RECORD OF RECOMMENDATIONS, VOTING RECORDS, AND CONDITIONS OF APPROVAL

SITE PLAN
NELSON LAKE ESTATES
LOT 44, BLOCK J
 ~AMENITY CENTER~

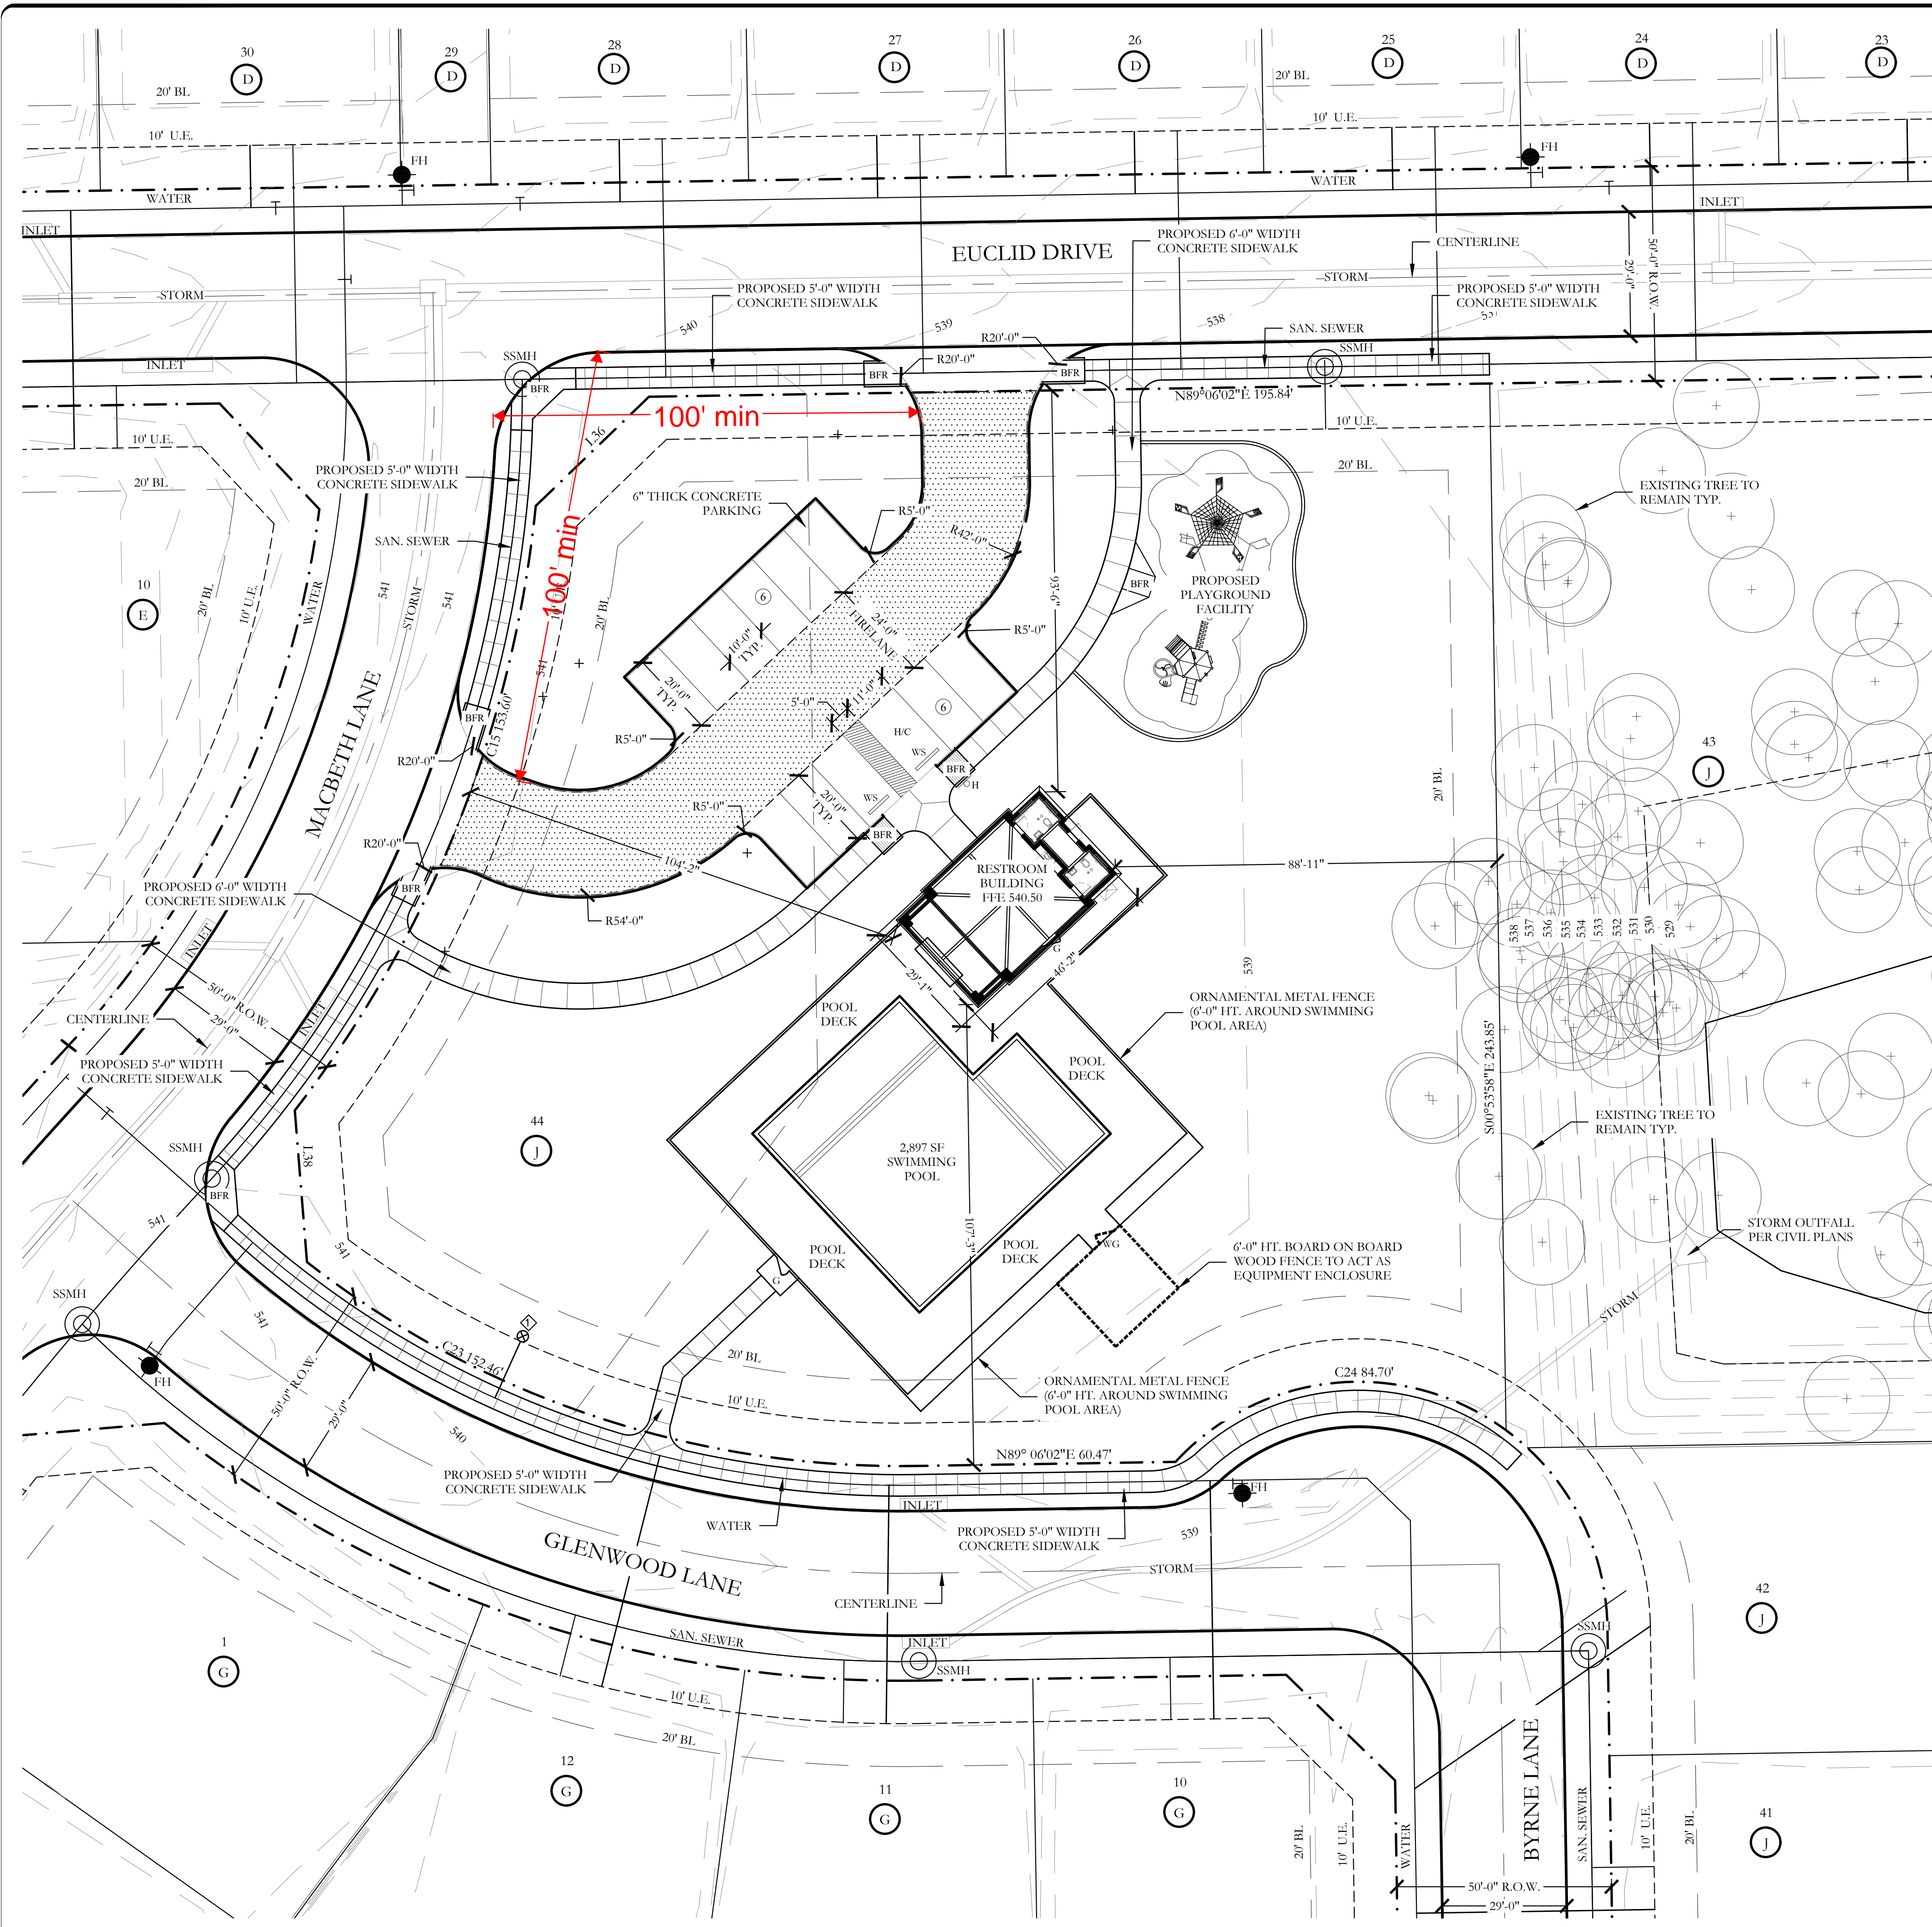
2. Tree mitigation plan approve

3. Informational only: There are several turfgrass species that are superior to Common Bermuda such as; Tif Tuf, Lattitude 36, Tahoma 31 which are more drought, cold, wear tolerant and conserve water.

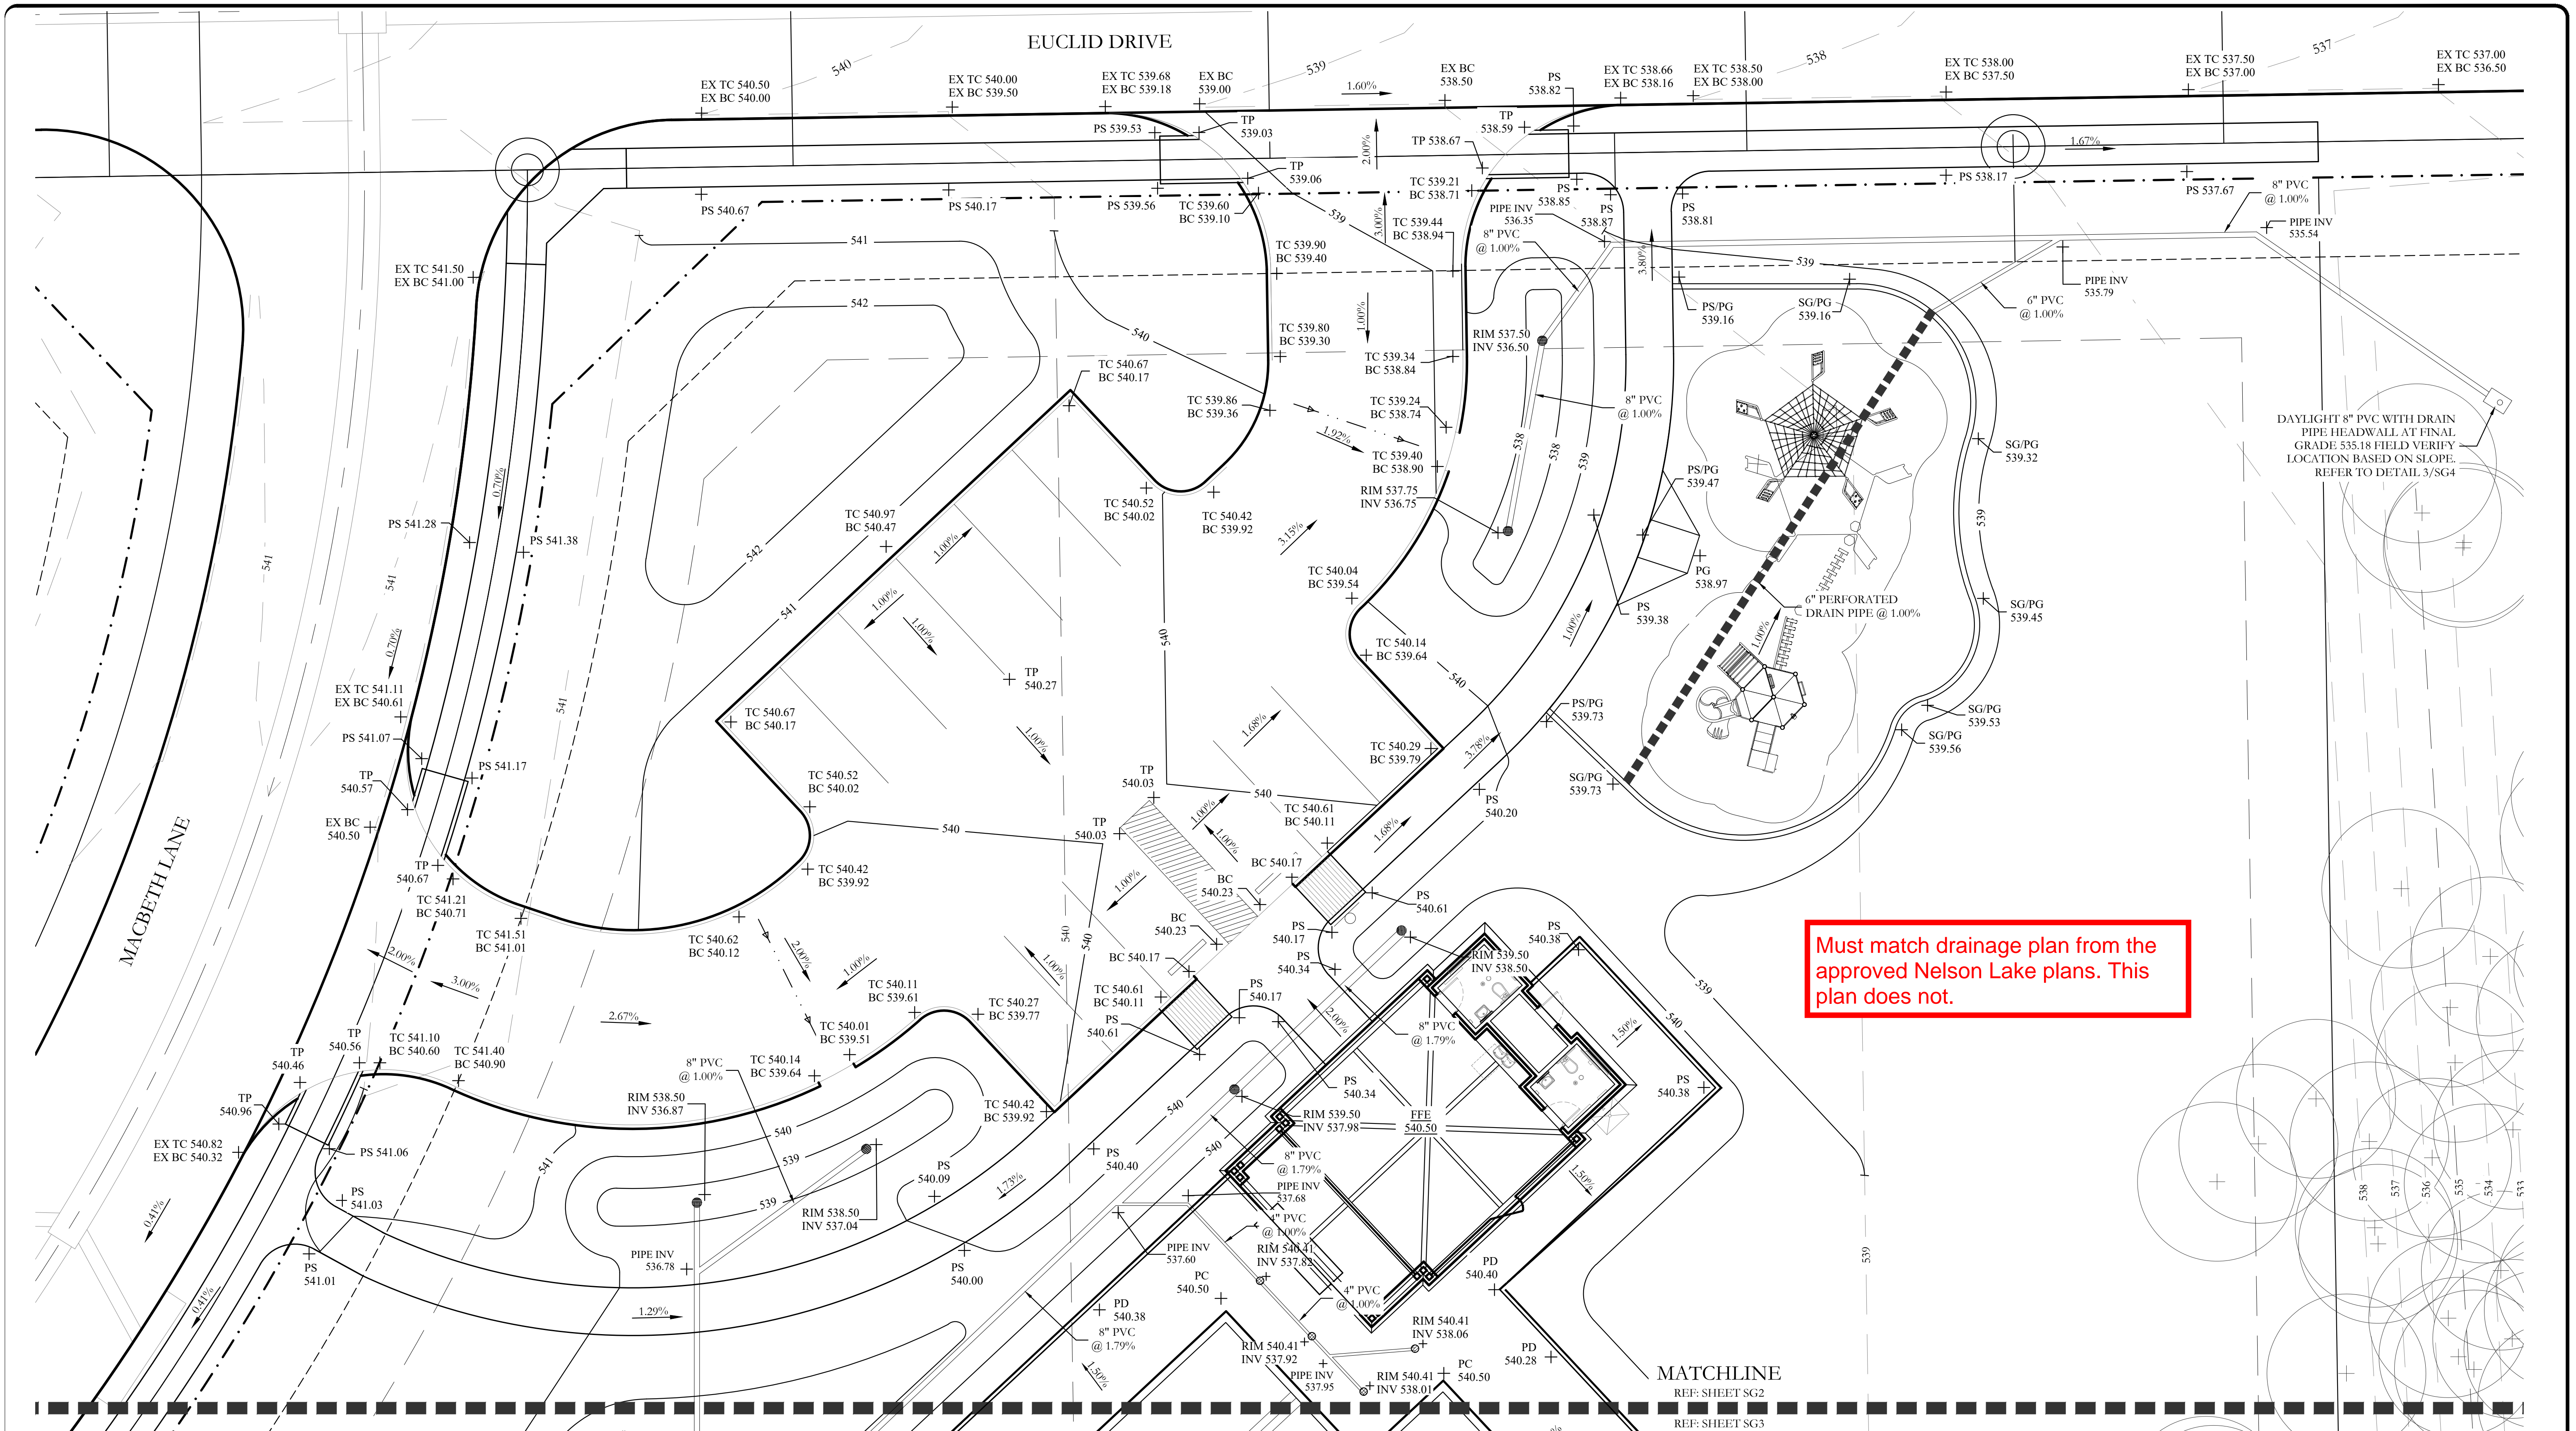
Use City detail
